INSPECTION TICKET INSPECTOR: IVR

SUBDIV: ADDRESS . : 324 GILCHRIST RD

APPL NUMBER: 17-50042224 CP MODULAR HOME

This letter is to confirm that Truss CCB37709 from the permit package is to be replaced with truss # CCB3711.

Job 91192 aaunT CCB37711 Truss Type CAPE COD Qty 1

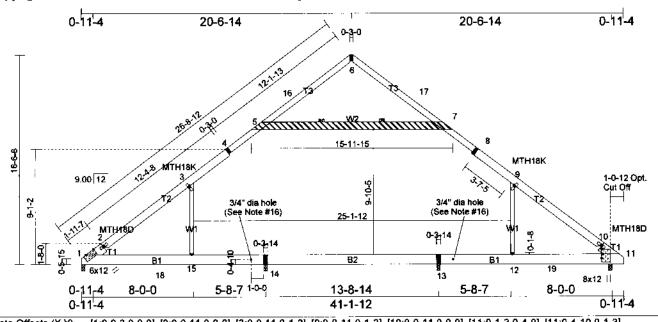
- 20) Based on: CCB37709
- 21) Revision: Removed bottom chord scabs, added hole note.
